**Re: NYCC April 29, 2026 Meeting  
Agenda Item NY32.2  
8 Parmbelle Crescent, Toronto  
Letter of Opposition**

## **PLANNING OPINION LETTER REGARDING ZONING BY-LAW AMENDMENT 25211052NNY16OZ – 8 PARMBELLE CRESCENT**

**RE: SERVICING LETTER – PEER REVIEW  
8 PARMBELLE CRESCENT  
NORTH YORK, CITY OF TORONTO**

Figure 7. Proposed Sub-Catchments at 8 Parmbelle Cres., City of Toronto

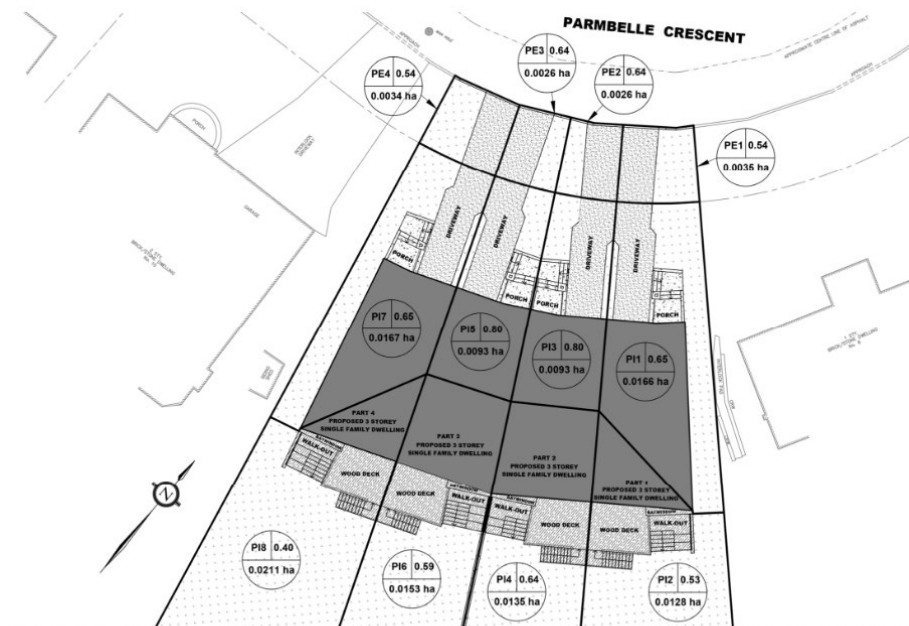
The City's Wet Weather Flow Management Guidelines (WWFMG) requires that the 100-year post-development flow be controlled to the 2-year pre-development flow rate. The FSR, prepared by Geomape Geotechnics Inc., compares post-development storm events with their corresponding pre-development events (e.g., 2-year post to 2-year pre, 5-year post to 5-year pre), but the report does not propose to control the 100-year post to the 2-year pre-development rate, which is required. The overall site was subdivided into parts as shown below. With drainage split to the north and south.

It is noted that no stormwater controls are proposed for the drainage to the south and the post development flows are summarized in the below table.

While there is a reduction in flows to the south in all storm events, the 100-year post development flow rate (22.732) exceeds the 2-year allowable release rate of 9.99 Ls. This discrepancy should be addressed by applying quantity controls.
